The following questions or issues were brought forward as part of recent South Mountain Citizens Advisory Team (SMCAT) meetings and designated as parking lot issues because the study team needed to conduct research to address the question or issue accordingly. In addition, questions submitted on blue question cards by SMCAT members and the public are answered below. Each comment received on a blue question card is written in this document as submitted. Each parking lot issue is addressed by presenting the question asked, followed by the Arizona Department of Transportation’s written response.

**Questions submitted at the March 29, 2010 meeting**

# Horizontal and Vertical Alignments, W59 Alternative, Western Section

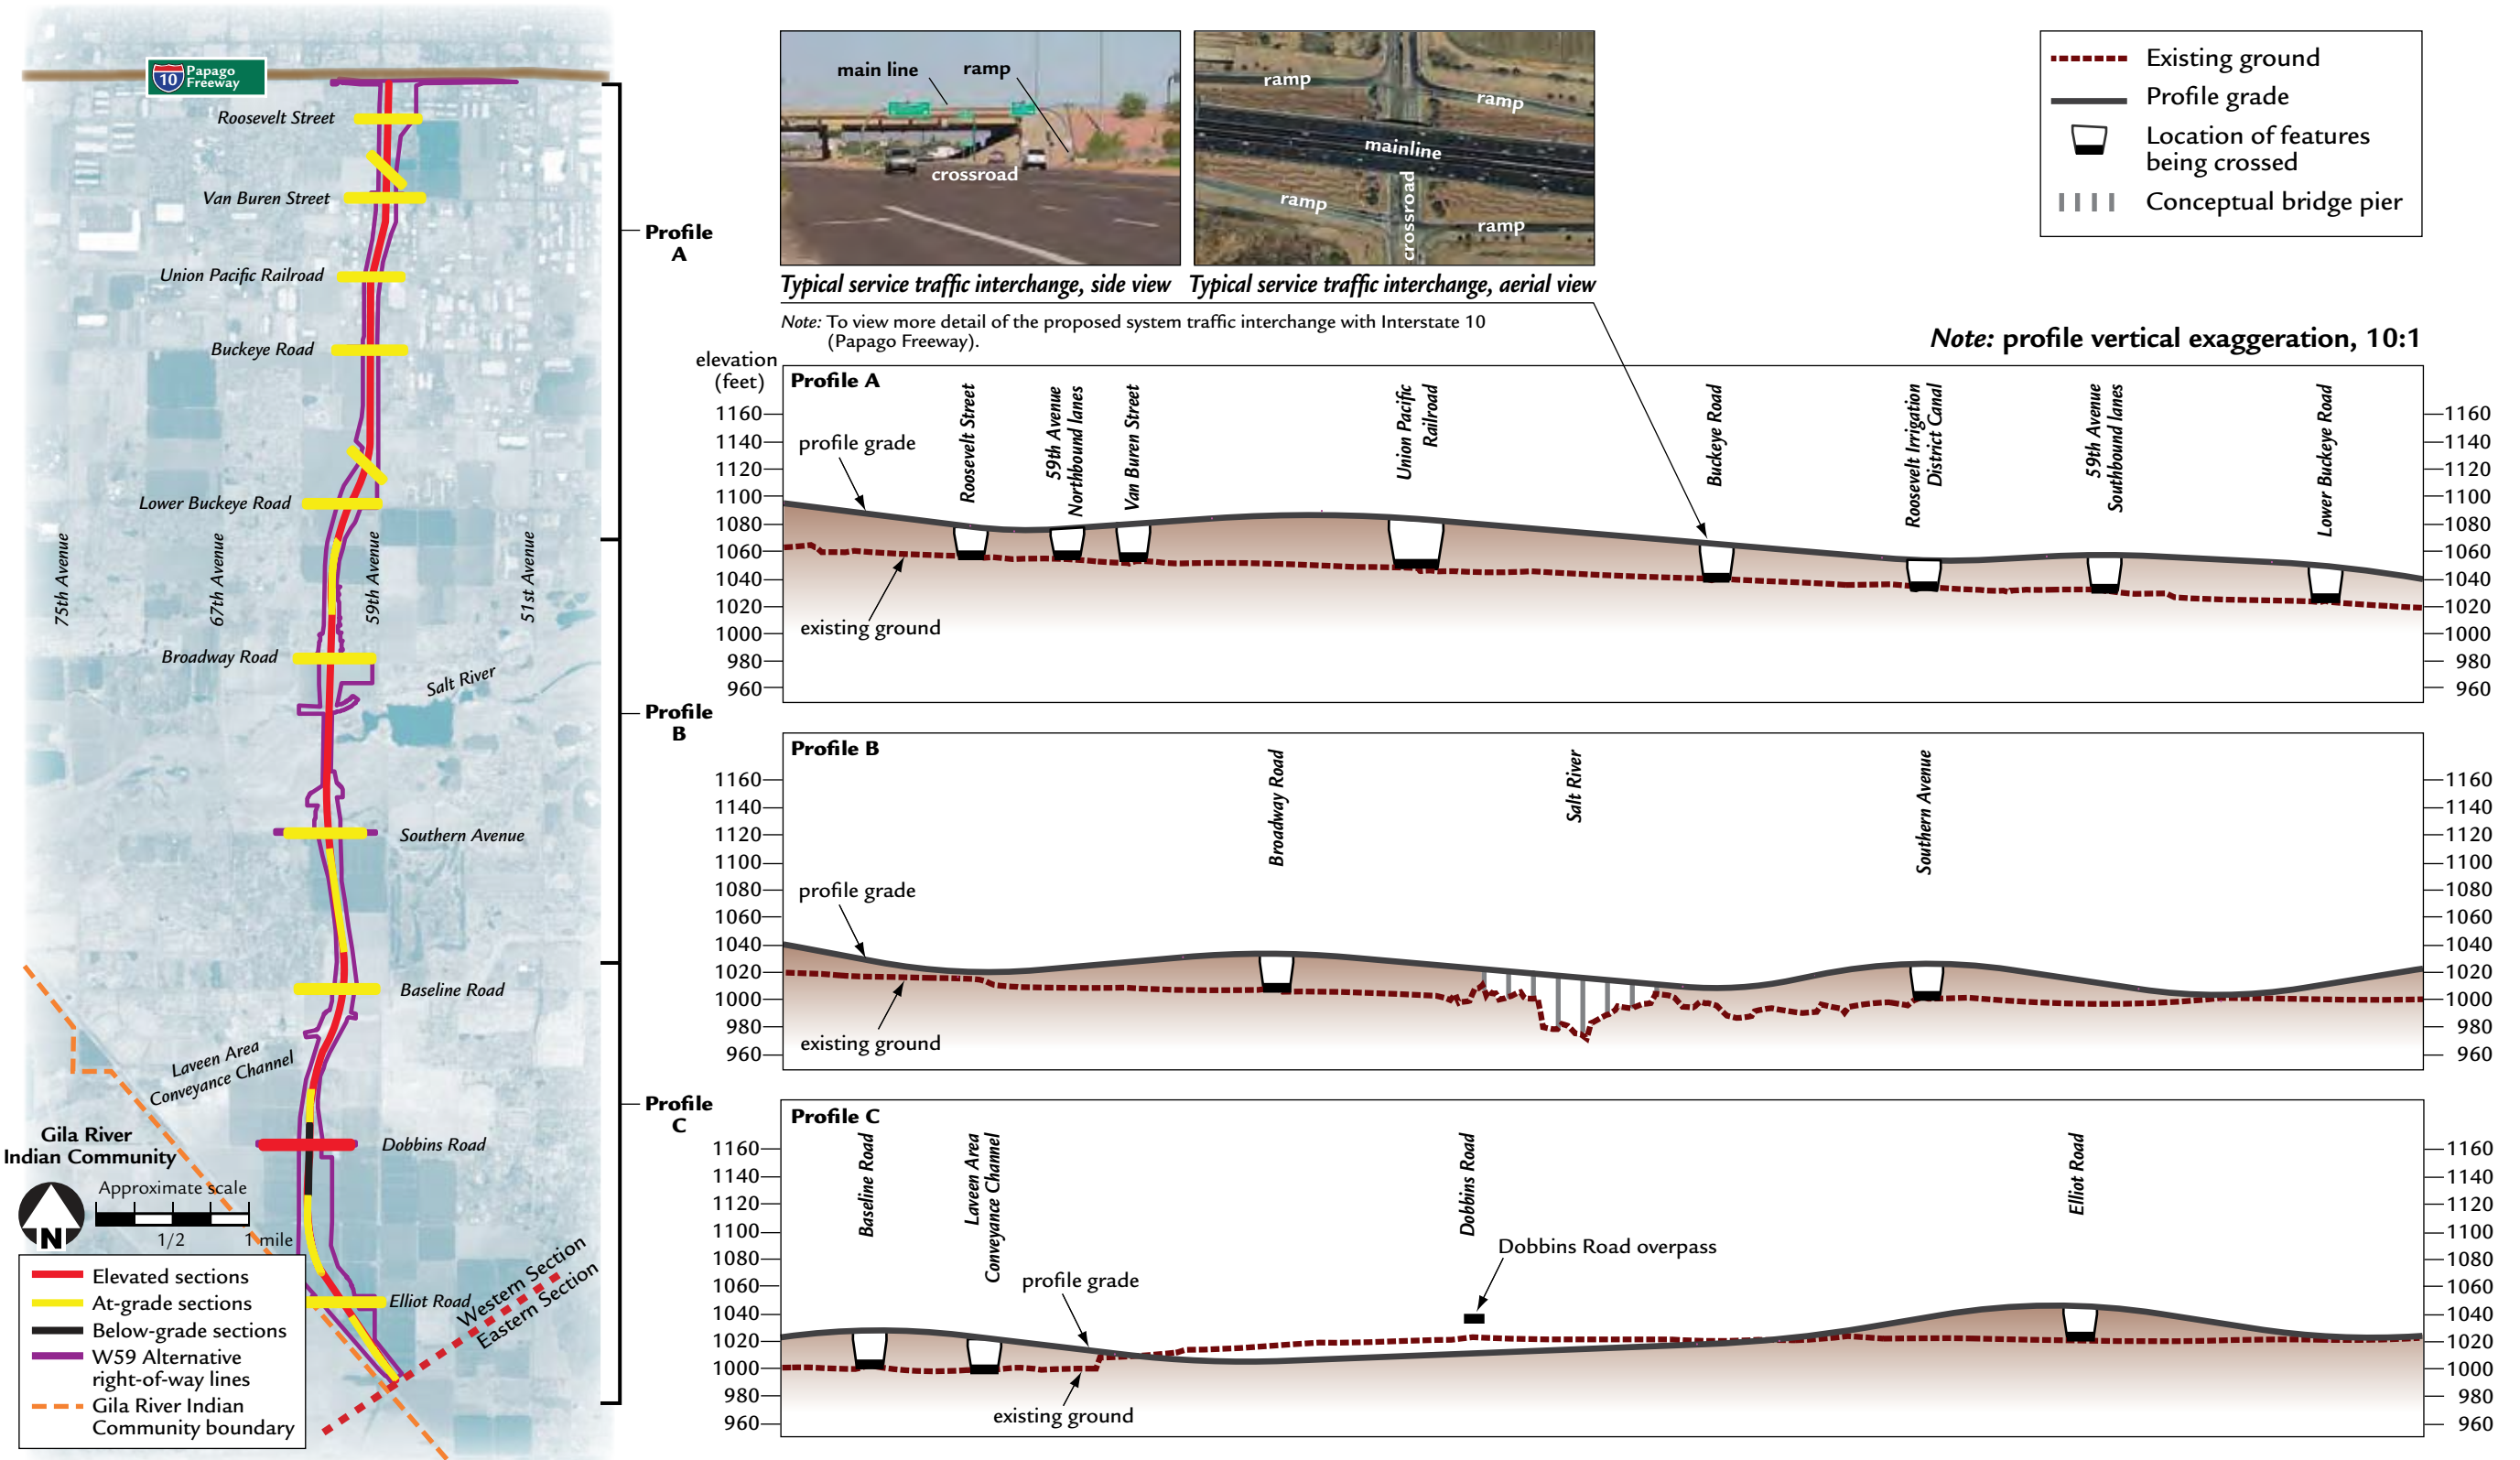
Topic	Public Question	Response
<p><b>Profile graphic</b></p>	<p>Do you have a profile graphic so we can see the heights throughout the corridor?</p>	<p>Profile graphics are attached to this memo and have been added to the project Web site. The vertical scale of the profile is exaggerated 10:1 to better show differences in elevation between the freeway and the existing ground.</p>
	<p>What is the highest elevation of the proposed South Mountain Loop 202 along Ahwatukee? We were told years ago it was about 18 ft.</p>	<p>The highest elevation above existing ground would be approximately 23 feet. The minimum clearance for a bridge structure over a street is 16.5 feet. The height of the bridge substructure would be approximately 6.5 feet. Therefore a total of 23 feet would be between the top of pavement for the street and the top of pavement for the freeway. This height is typical for freeway overpasses in Maricopa County. Such examples include Loop 101 (Agua Fria Freeway) over Thomas Road, I-10 (Maricopa Freeway) over Baseline Road, and I-17 over 7th Avenue.</p>
